# Backfeed v240

## 145.2.4 PSE PI

## 145.2.10 Power supply output

Figure 145–29a — Reflected voltage requirements

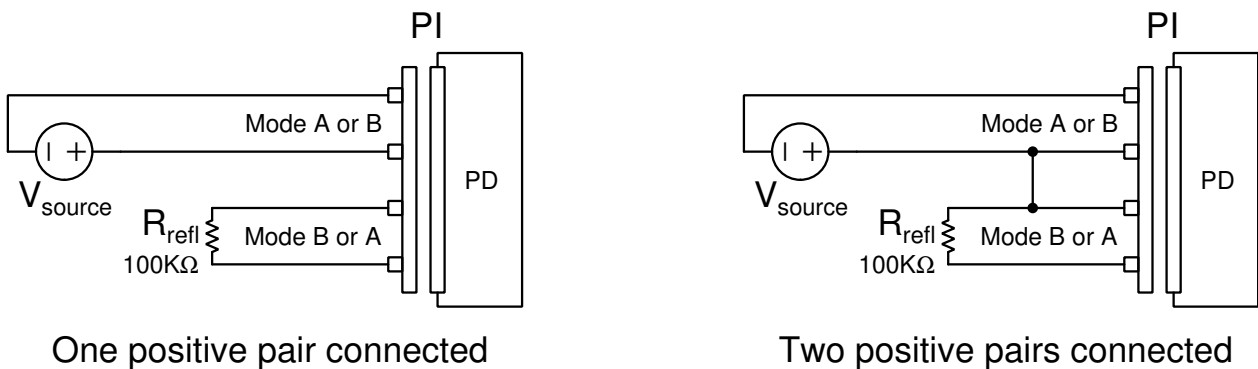
For a single-signature PD, when any voltage in the range of 0 V to  $V_{Port\_PD-2P\ max}$  is applied per any of the valid 2-pair configurations, defined in Table 145–20, that have only a single pair connected to positive  $V_{PSE}$  (see Figure 145–29a), the voltage on the Mode not connected to the voltage source, with a 100 k $\Omega$  resistor connected across that Mode, shall not exceed  $V_{refl}$  as defined in Table 145–29.

For a single-signature PD, when any voltage in the range of 0 V to 10.1 V is applied per any of the valid 2-pair configurations, defined in Table 145–20, including those with two pairs connected to positive  $V_{PSE}$  (see Figure 145–29a), the voltage on the Mode with at least one pair not connected to the voltage source, with a 100 k $\Omega$  resistor connected across that Mode, shall not exceed  $V_{refl}$  as defined in Table 145–29. This requirement does not apply if a voltage greater than 10.1 V has been applied on either Mode until the voltage on both Modes has been less than  $V_{Reset}$  for at least  $T_{Reset}$ .

For a dual-signature PD, when any voltage in the range of 0 V to  $V_{Port\_PD-2P\ max}$  is applied per any of the valid 2-pair configurations, defined in Table 145–20, including those with two pairs connected to positive  $V_{PSE}$  (see Figure 145–29a), the voltage on the Mode with at least one pair not connected to the voltage source, with a 100 k $\Omega$  resistor connected across that Mode, shall not exceed  $V_{refl}$  as defined in Table 145–29.
